Access Compliance Report Public Rights-of-Way (Curb Ramps)

Main Street: SLEEPY_HOLLOW_LN Cross Street: SIENNA_PKWY Location: E

ADA ID: RPRK211021135549 Ramp Type: Type 1 - Perpendicular Diagonal Initial Pass/Fail: Fail Overall Compliance: No Severity Score: 2

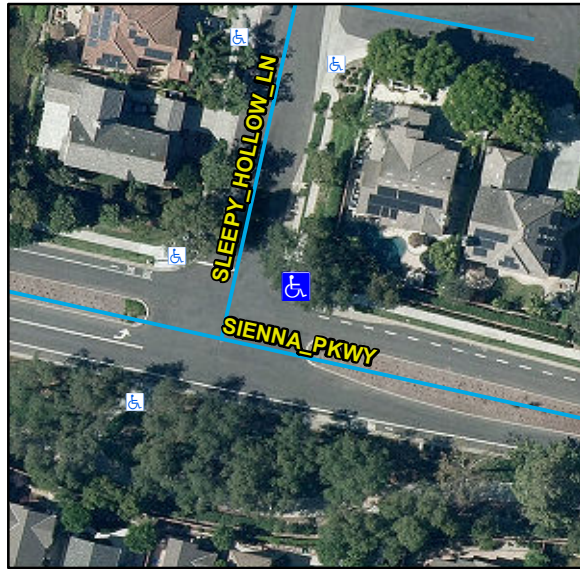
R304.2.2, R304.5.3, STD 1115

Remove & Replace Curb Ramp With Two New Directional Ramps or Equivalent.
